REFERENCE	V2.0
STATUS	For Information

PROPOSED SOLUTION

R0083A - CHANGES TO SUPPLY NUMBER FORMAT FOR MHHS

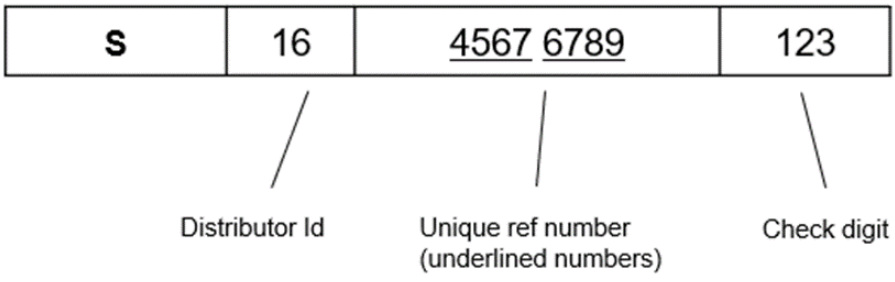
The proposed solution, presented as Option 3 for the Party impact assessment, has specifically been developed to facilitate removal of the top line entirely from the Supply Number. Only the bottom line of the S Number would remain, effectively only providing the MPAN. This would allow a consistent approach to be applied across all electricity Metering Points and would align to the existing gas requirements around the provision of the Meter Point Reference Number (MPRN).

The legal text in the Supply Number Format within the Data Specification will be updated to remove all top line requirements.
